## Addition to A. Mario Loiederman Middle School, Mandatory Referral, MR2019018

This report is staff's review of the Mandatory Referral for the construction of a performing arts facility addition to A. Mario Loiederman Middle School, submitted by Montgomery County Public Schools (MCPS), pursuant to the Maryland Land use article, Section 20-301. The Planning Board action on a Mandatory Referral is advisory.

Figure 4: Location of Recommended Bicycle Master Plan Sidepath

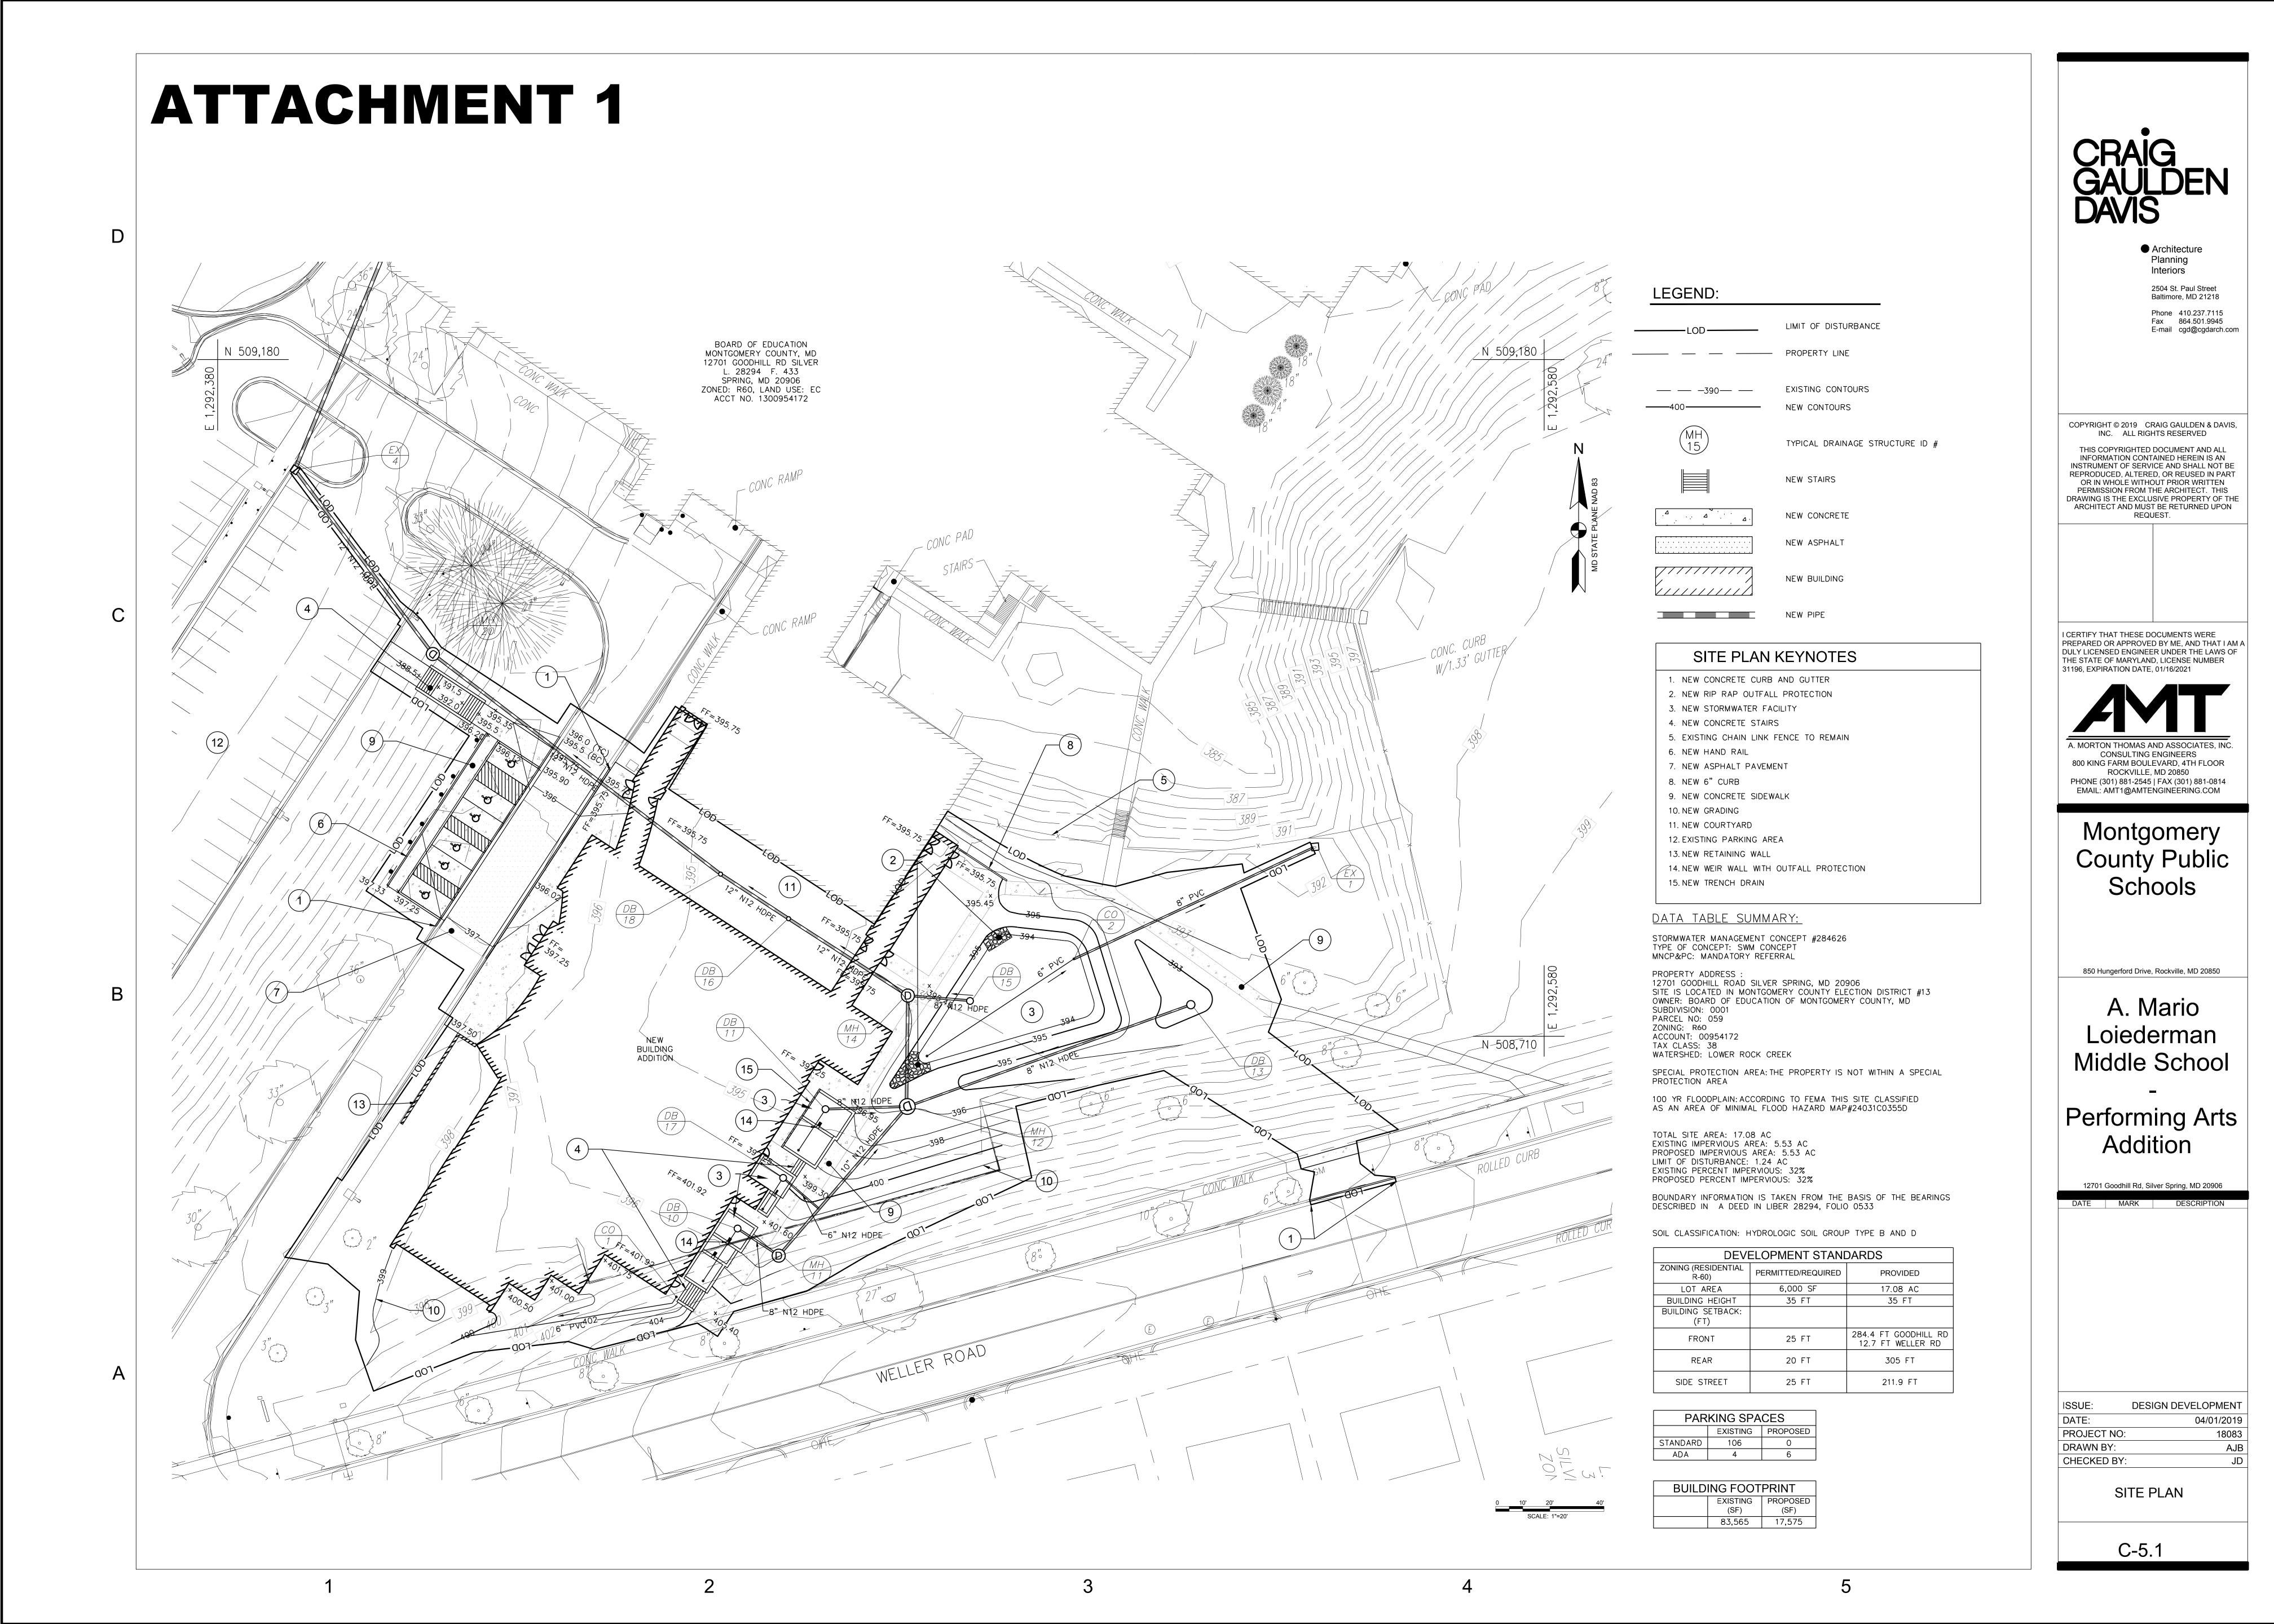
At this time, the applicant is not proposing to provide the ten-foot (10') sidepath on Weller Road, per the 2018 *Bicycle Master Plan*. While the site slopes inward away from the right-of-way, staff feels that the intent of the *Bicycle Master Plan* could be achieved to support both pedestrians and bicyclists. In support of Montgomery County's Safe Routes to Schools program and the County Vision Zero goals, staff strongly encourages MCPS to do the following:

- Create a sidepath ten feet in width, extending from the asphalt trail to the east of the property to roughly the location of the existing basketball court ramp. The path may be narrowed to eight feet in width to minimize conflicts with existing trees where necessary. Widening could potentially be achieved by extending paving approximately four feet from the back of sidewalk and two feet from the existing 12-foot landscaping strip. This approach attempts to minimize conflicts with the existing utility/tension pole and trees located in the landscape strip (extent depicted as "A" in Figure 4).

- East of the ramp, create the sidepath, ten feet in width but narrowed to eight feet in width where necessary to minimize tree impacts. This approach attempts to minimize conflicts with the existing utility pole at the back of sidewalk and trees located in the landscape strip (extent depicted as "B" in Figure 4).

- Beyond the site driveway on Weller Road, create a sidepath that is ten feet by taking six feet from the back of the sidewalk (or four feet from the back and two feet from the front) for the remaining extent of the property. There will be a pinch point between the existing utility pole and the transformer box near the bus stop. Ideally, the applicant would move at least one of these utilities beyond the pedestrian realm (extent depicted as "C" in Figure 4).

Any portion of a widened sidewalk that extends beyond the right-of-way would need to be placed in a Public Infrastructure Easement (PIE). Staff recommends that any widened sidepath facility fronting A. Mario Loiederman Middle School be extended along the frontage of adjacent Weller Road Elementary School to best support the County's Safe Routes to Schools program and Vision Zero policies.
